DELEGATED APPLICATION REPORT

Address: Land between Weldale Street and Chatham Street, Reading

Application No: 211931/NMA

Proposal: Non-material amendments to permission 170326 (granted on 15/03/2018) to alter the wording of conditions 2 (approved plans) to provide 13 electric vehicle charging points adjacent to the western site boundary, alterations to flat entrances at lower ground floor level on western elevation of Block A1, amendments to boundary wall on the north elevation of Block A1 fronting Weldale Street, relocation of cycle stands adjacent to the east elevation entrance of Block A2, relocation of roof level flue at Block A1 fronting Chatham Street, amendment to alignment of retaining wall to the south west of Block A1, proposed handrails to ramped section of path to the south of Block A2 and amendment to the planting bed in the courtyard of the A Blocks.

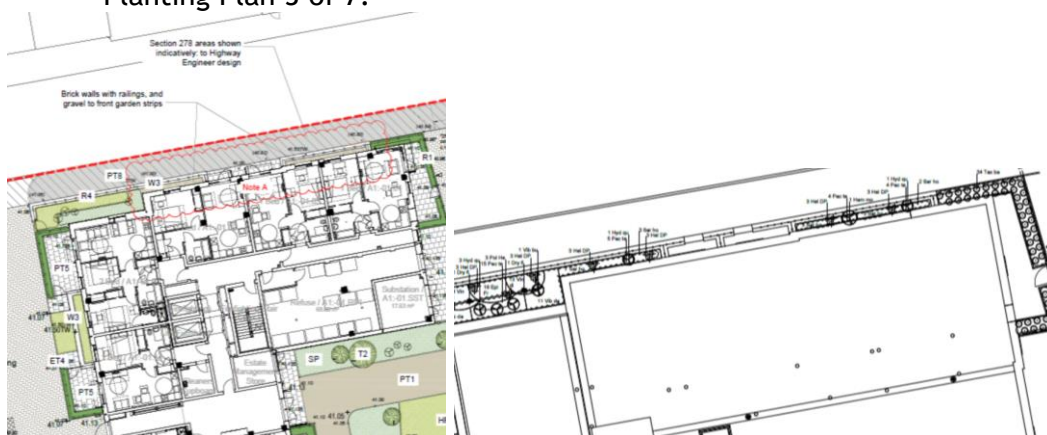
- The provision of additional EV charging points is supported and is acceptable.
- No transport objections to the amendments to the west elevation of Block A entrances.
- Amendments to boundary wall on Weldale Street for Block A1 - Clarification required from transport that if the boundary wall is to be removed, then the doors serving the residential units must open inwards away from the footway.
- Cycle parking amendments are acceptable in principle, but clarification is required to ensure the cycle standards will be located 650mm away from the grassed landscaping (so that it is fit for purpose).
- No transport objections to any other elements of the works

I have reviewed the agent's response who has confirmed that the doors will not encroach onto the footway, and the cycle stands will be located a suitable distance from the soft landscaped area.

Therefore, I have no further objections to the NMA application.

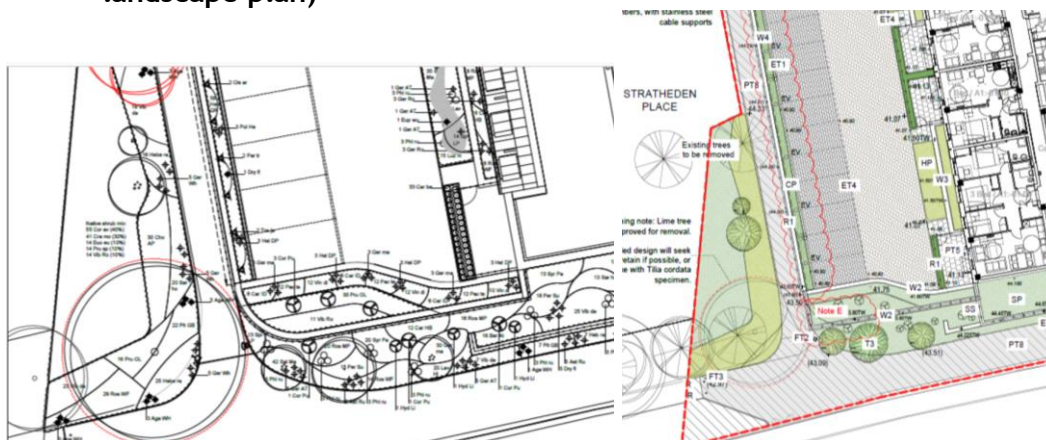
- a) **amendment to alignment of retaining wall to the south west of Block A1 (Note E on landscape plan)**

The above extracts are from approved (under 200476/APC) 1903-MWA-00-XX-DR-L-1901 Rev 02 Weldale Street, Planting Plan 1 of 7 (left) and submitted Site Landscape GA Plan 1903-MWA-00-XX-DR-L-0001 Rev 14 (right). The change will mean a minor change in the planting in that area but as the tree planting would be unaffected, the Natural Environment officer has no objections. The Planning Officer should decide whether a Planting Plan should be submitted.

As per the RBC Natural Environment Officer comments, there are no concerns raised with this change to the proposal, subject to it also being reflected in updated landscaping details (as per the comments above). The change is minor in nature and scope.
